**ANNEX F**

**C-111**

**DRAFT  
ENVIRONMENTAL EVALUATION FOR THE STRUCTURAL  
ALTERNATIVE PLANS  
FOR THE C-111 DRAFT GRR**

**SUBMITTED TO THE U.S. ARMY CORPS OF ENGINEERS**

Figure 3: Sketches of Base, Alternatives 1, 2 and 3

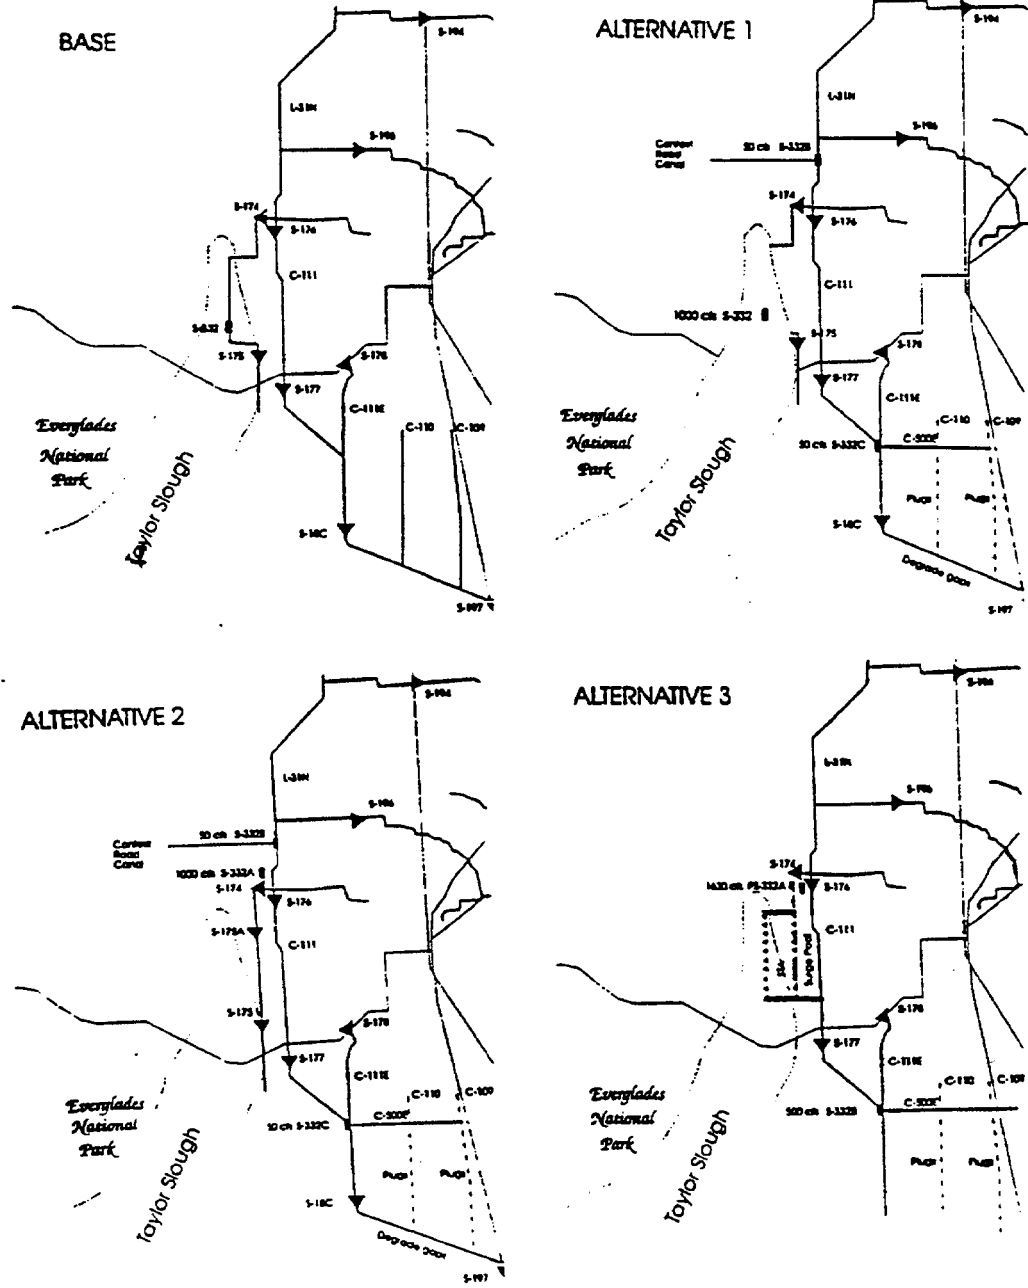
- Alternatives 1, 2, 3, 5 and 7 provide increased flood control and water supply benefits by pumping into the main channel of Taylor Slough through large pumps located at a single location. In contrast, alternatives 4 and 6 use five moderate size pumps to spread water out over the wetlands of the Rocky Glades and northern Taylor Slough. The increased pump capacity in the headwaters and northern portion of the Taylor Slough basin provide for large increases in wet season flows through the Taylor Slough Bridge cross-section, but produce only modest additional flows into the downstream areas of Taylor Slough and Florida Bay.

- None of the alternatives significantly restore more natural conditions in the Eastern Panhandle watershed of the lower C-111 basin, however all plans degrade the spoil piles on the southern bank of the C-111 canal. Alternative 5 partially backfills the C-111 canal south of S-18C, and Alternatives 3 and 4 backfill the canal completely south of the confluence with C-111E. All, except Alternative 7, place plugs in C-109 and C-110,

but do not backfill the canals. Additional flood control and water supply discharges to the Eastern Panhandle are proposed in all but Alternative 7. A new spreader canal (C-500E), aligned eastward from the confluence of the C-111E and C-111 canals, is added in Alternatives 1 through 6. This canal would be supplied by either a 50 cfs pump (Alternatives 1, 2, and 6) or a 500 cfs pump (Alternatives 3, 4, and 5).

Figure 50: Proposed Alternative 8

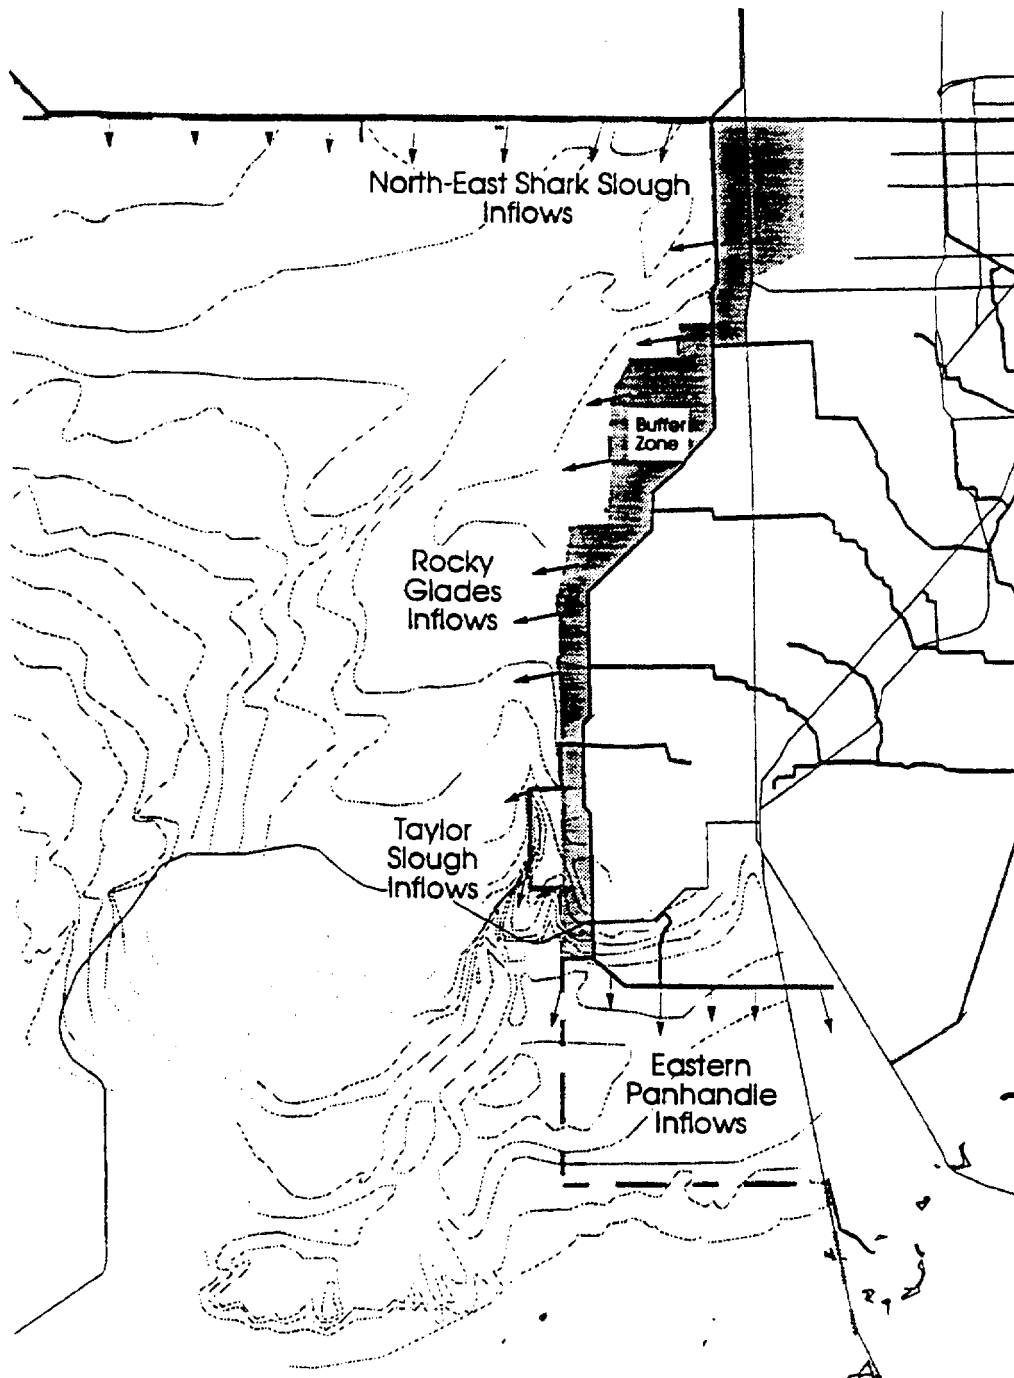
The conceptual details of this alternative are divided into a structural component and an operational component, the details are as follows (see Fig. 50):

Figure 2: Alternative 6a

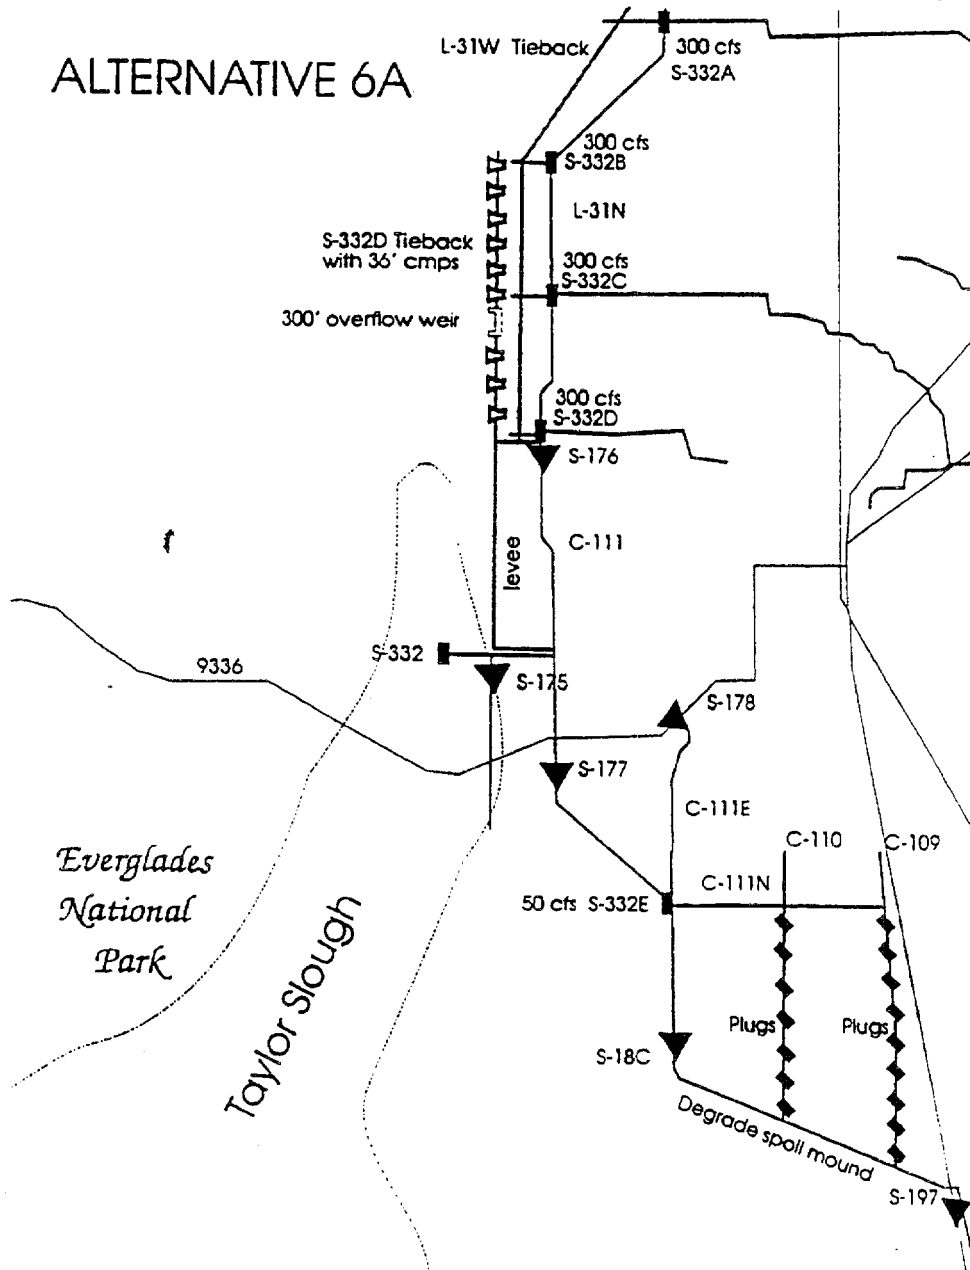
- **Alternative 6A.** This plan is a modification of Alternative 6 and addresses the large seepage losses along the L-31N canal, and the need for detention/retention areas. The components of this plan are shown in Fig. 2 and the specific improvements are discussed below:
